Link Section Discussion

IEEE 802.3bt 4 Pair PoE

8802-3/802.3 REVISION REQUEST

STANDARD: IEEE Std 802.3-2015
CLAUSE NUMBER: 1.4.254
CLAUSE TITLE: link section

Diagrams - 4

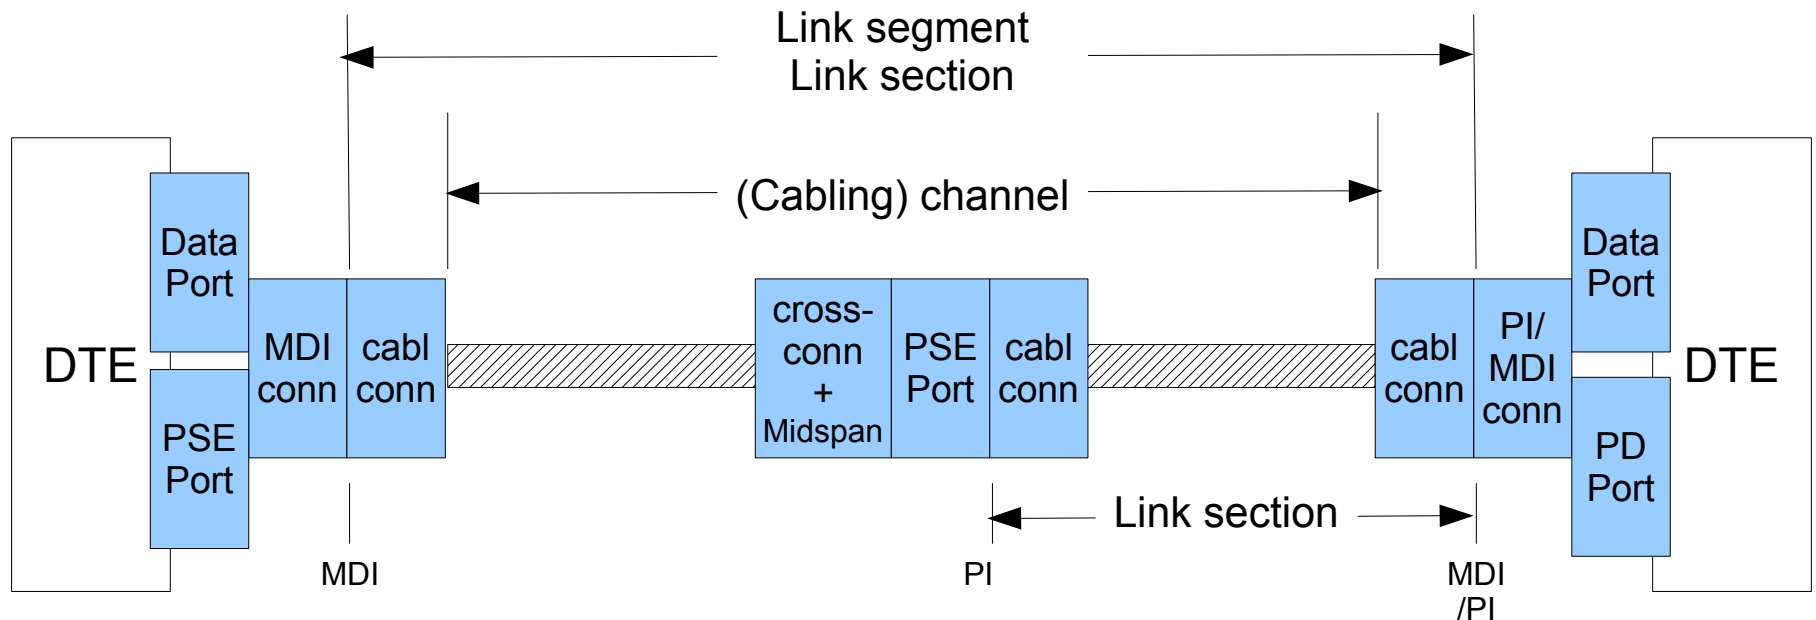
- Link section (apparently 2, not really)
- Link segment

Not complex, DC block precludes endspan
